Doggendorf - Pool Proposal
 3-Bedroom Septic Relocation Proposal
 104 Lonnie Betts Drive

Adams
 Soil Consulting
 919-414-6761
 Job #830

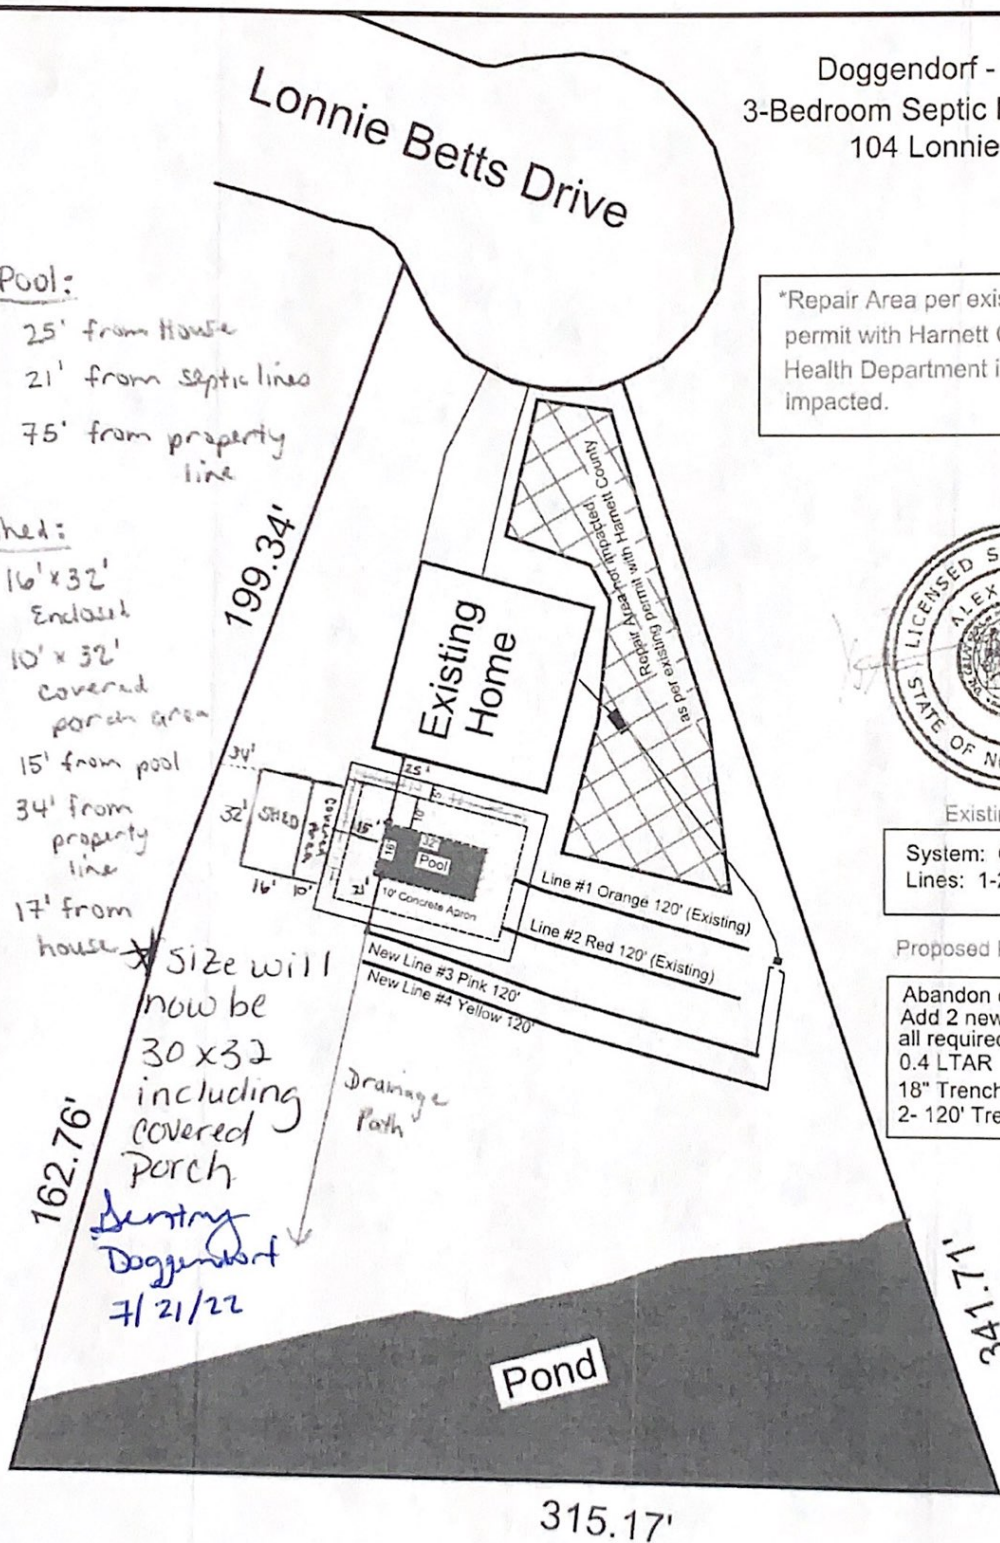
Existing System

System: Gravity
 Lines: 1-2 (140')

Proposed Primary System Modification

Abandon existing trenches.
 Add 2 new line as shown meeting all required setbacks.
 0.4 LTAR
 18" Trench Bottoms
 2- 120' Trenches - Innovative Product

* Size will now be 30 x 32 including covered porch
 Denny Doggendorf
 7/21/22
